# **A G E N D A**

## **Architectural Review Board**

**March 24, 2015**

504 S. Perry Street

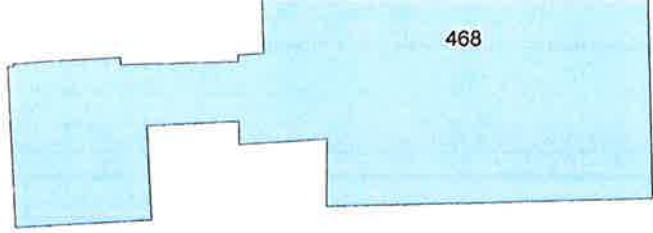
- The design guidelines state “Proposed signs should not exceed 20 square feet of surface area. Designs for the mounting, framing, etc. must be approved. The material for the mounting should be compatible with the materials of the building. Style and color of lettering must be compatible with the building location. Location of sign on lot must be approved. Lighting: top or ground lighting, such as floods or spots. Interior lighting, if shielded. No moving or flashing lights.”
- Sign is within the size parameters, lighting is not requested.

Designer: **KL**  
 Date: **03-03-15**  
 Signs & Graphics, Inc. Sketch No: **MONT 101**

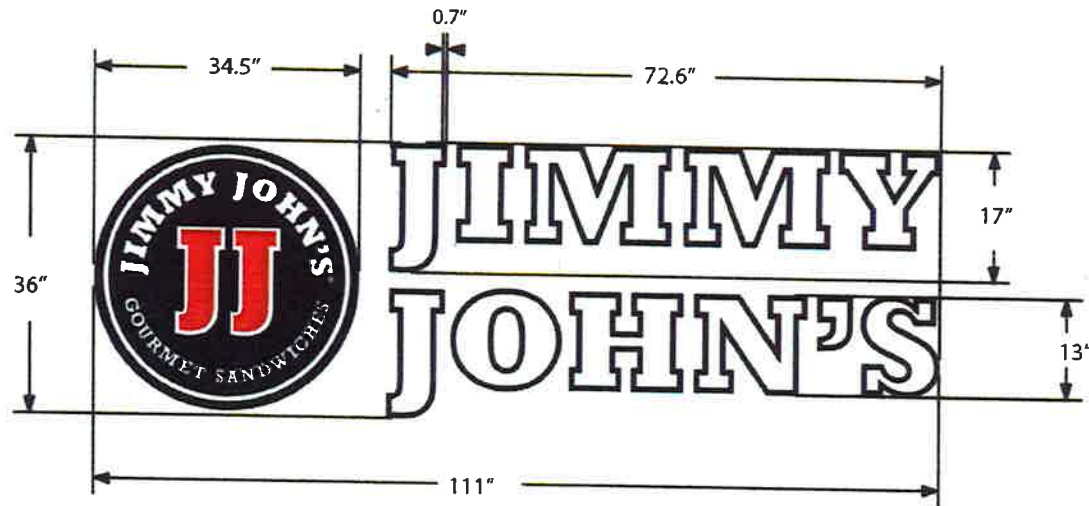
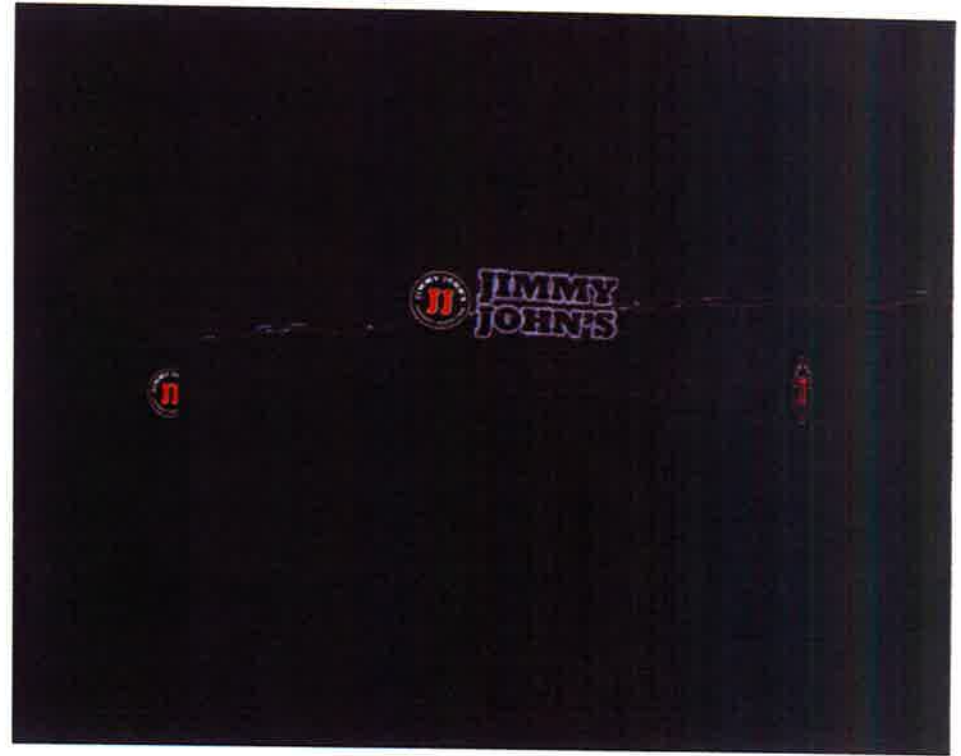
- The 2 blade signs are within the size parameters, the wall sign exceeds the recommended 20 square feet. The Board needs to determine if the scale of the sign as proposed can be accommodated by the scale of the building.

- The wall sign is using a halo back lighting, the Board needs to determine if this is appropriate illumination. The Board has required spot lighting for proposals requesting illuminated letters (e.g. Wells Fargo at Union Station), but in my tenure, a request for halo back lighting has not been requested.

Designer: KL  
Date: 03-03-2015  
Sketch No: MONT 100

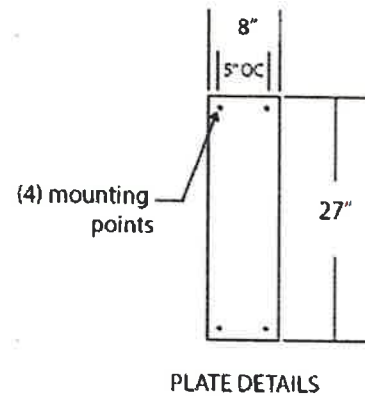
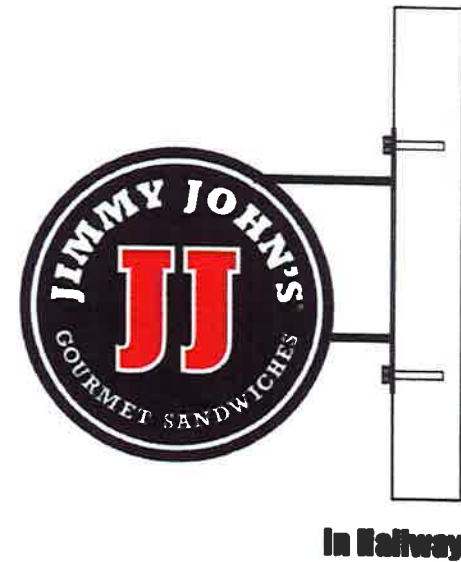
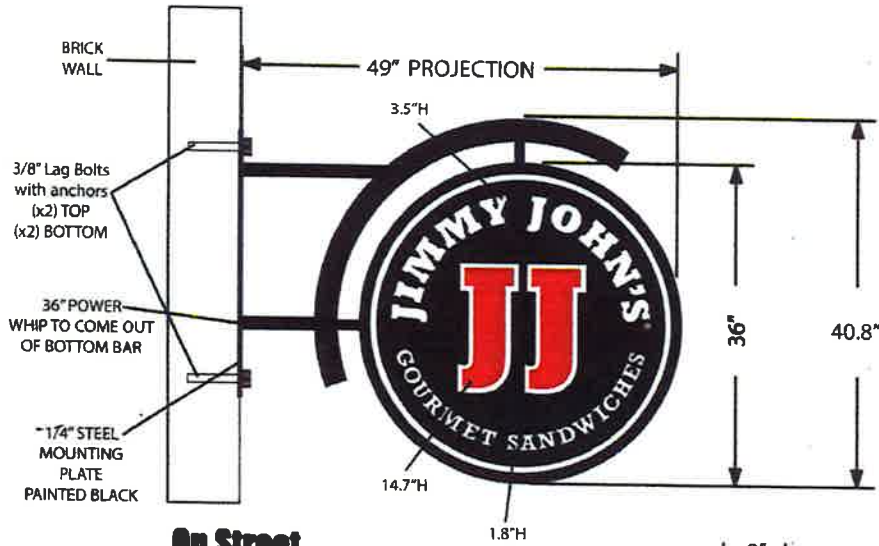
- Generally, the Board has only approved interior illumination when only the letters were illuminated, in an effort to avoid the appearance of glowing plastic signs. It appears that the black sign face on the blade sign will be opaque and that only the letters will illuminate.

# Back-YARD LAYOUT

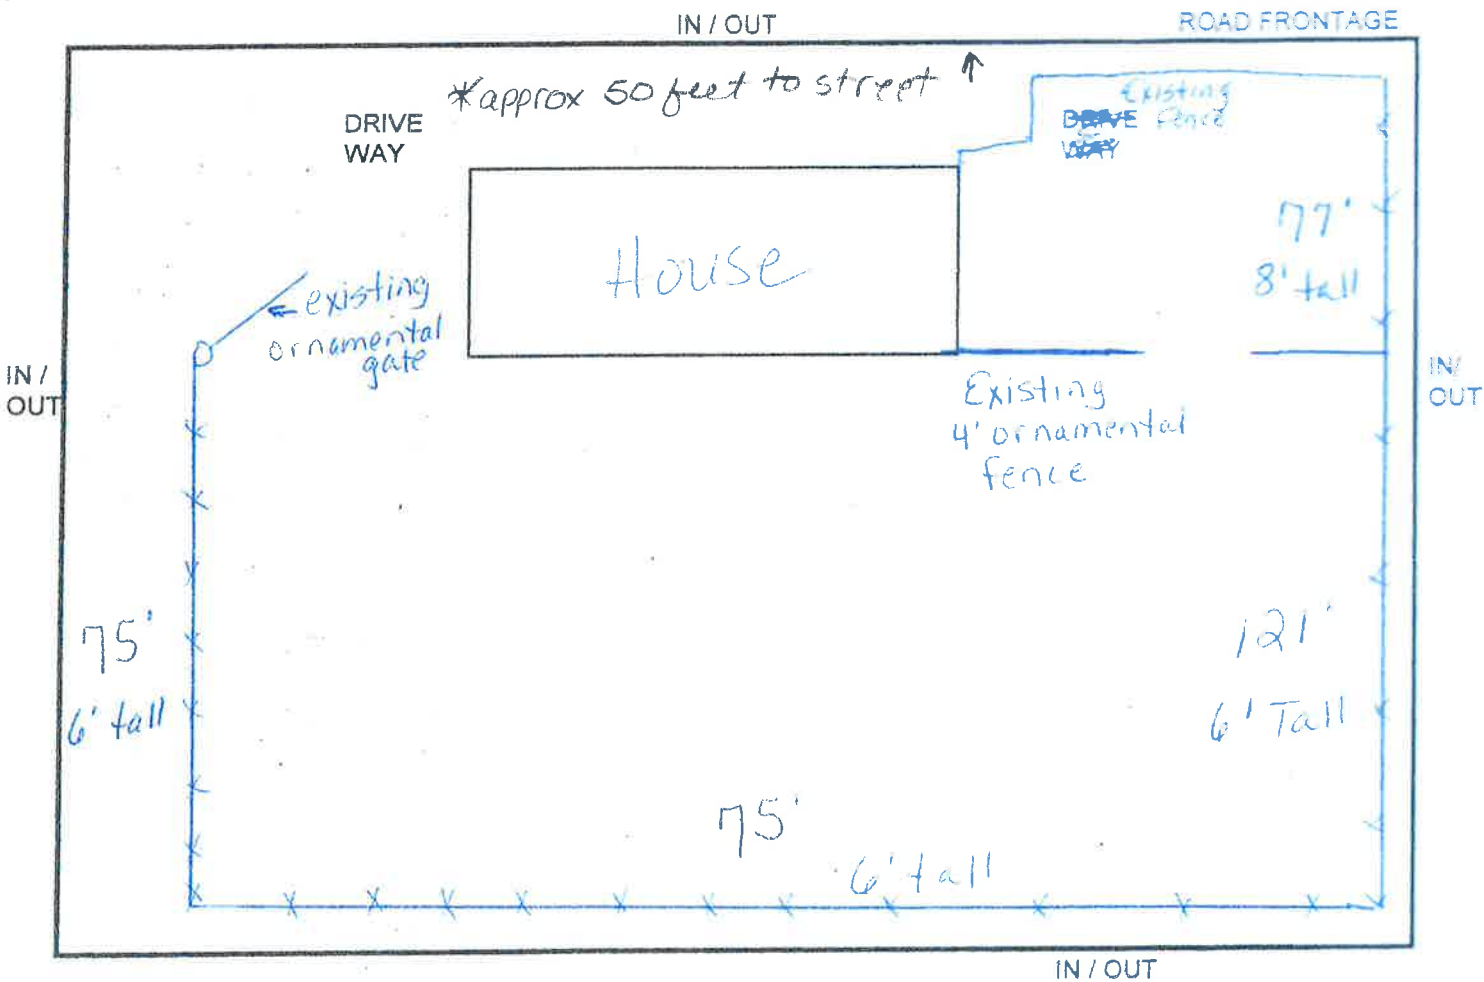
- The ARB guidelines allow rear yard fences up to 6'. Taller fences have been approved when circumstances may warrant additional height.
- Zoning requires that any fence that is over 7' in height receives a variance prior to installation. That portion of the fence cannot be installed without a variance from the Board of Adjustment.

805 Cloverdale Road

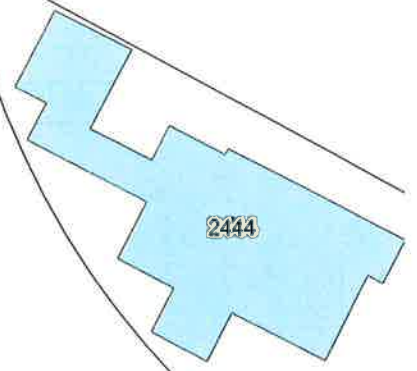
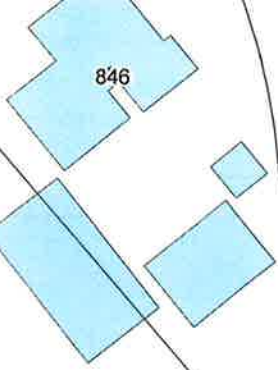
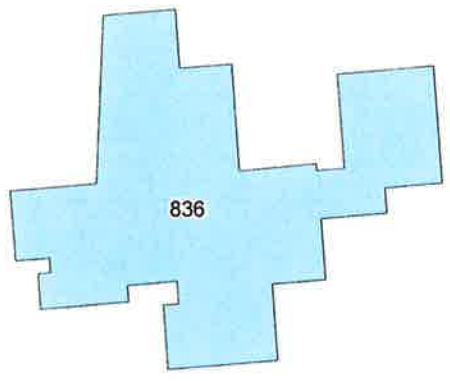
- The rear yard fence of the adjacent property is an open metal fence of similar construction.
- The owner has contacted the Urban Forester about submitting a landscaping plan for the Right of Way, which falls outside the ARB process.

ARB Submittal  
3333 Lexington Road

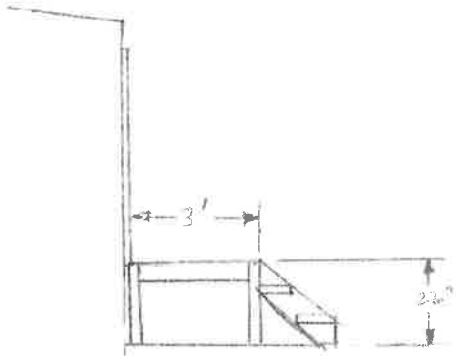
- The Board has approved steel doors on rear elevations.
- The entry porch does not appear to be original to the house.
- Generally when the Board has approved the installation of shutters the shutters:
  - Are appropriate for the style of the house;
  - Are scaled so that if the shutters were operable, they would close over the window. The proposed shutters are taller and narrower than the window opening.

RESIDENCE  
PATIO  
RENOVATION  
FOR  
BROWN RESIDENCE  
3233 MARTIN LN.  
MONTGOMERY, AL  
ELEVATIONS

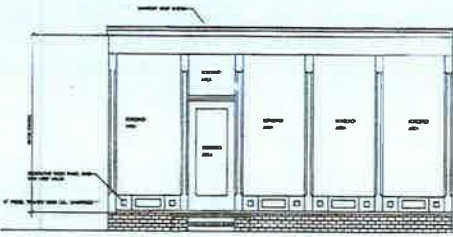
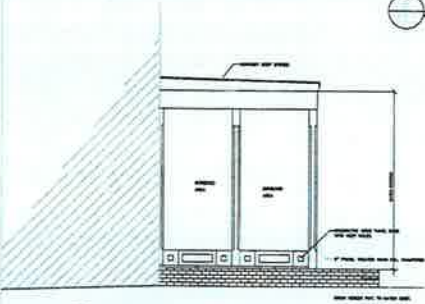
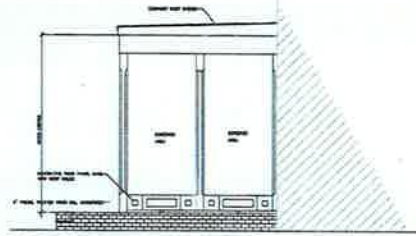
- Screening porches, particularly side porches, has not been an issue of concern for the Board in the past.
- The Board needs to determine if the proposed railing detail is appropriate for the house.
